MESA-BOOGIE
SUBWAY BLUES

April 1998

HUM REDUCTION MOD
FOR POTTED CIRCUIT BOARDS

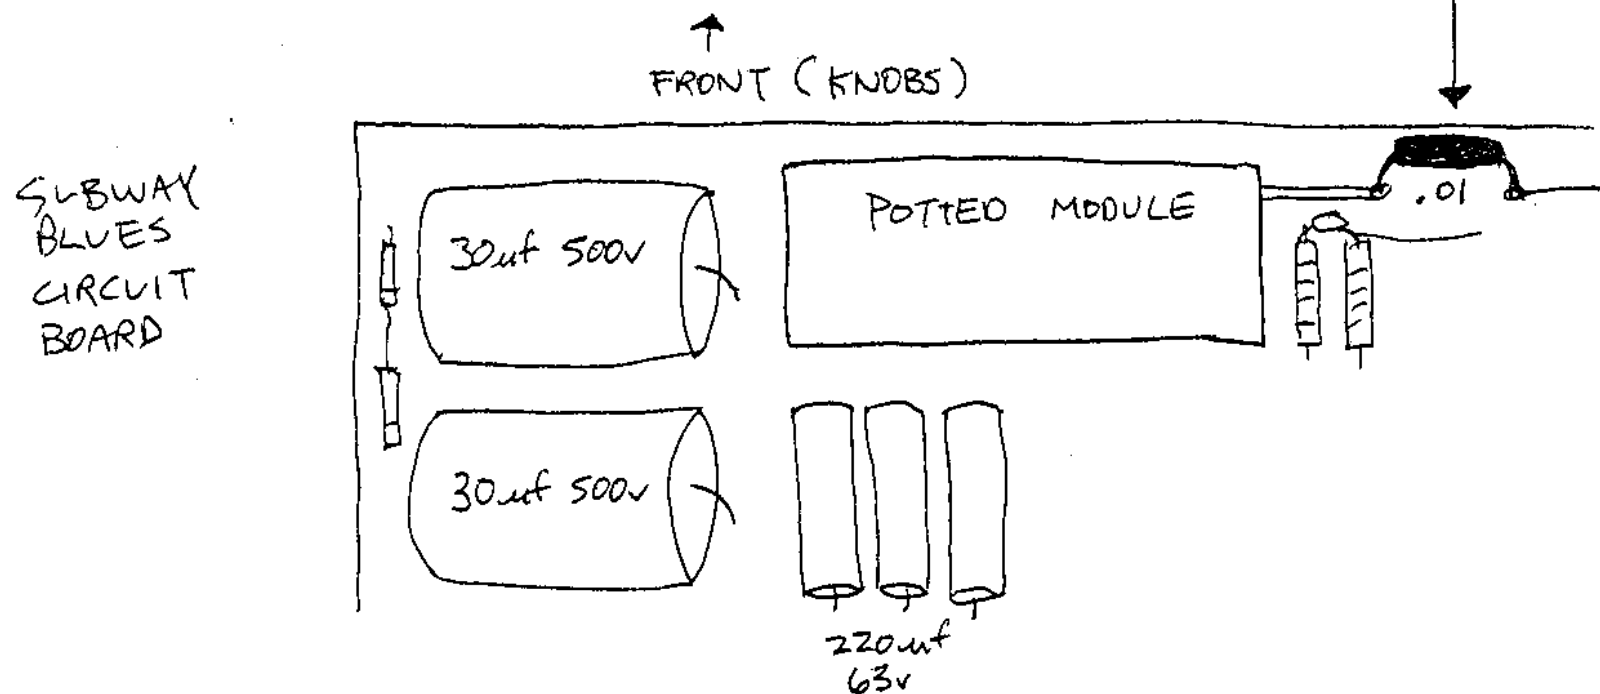
CHANGE THIS CAP (.01)
TO .68/250V

1. Remove orange .01/400v cap from above location
2. Replace with supplied .68/250v cap
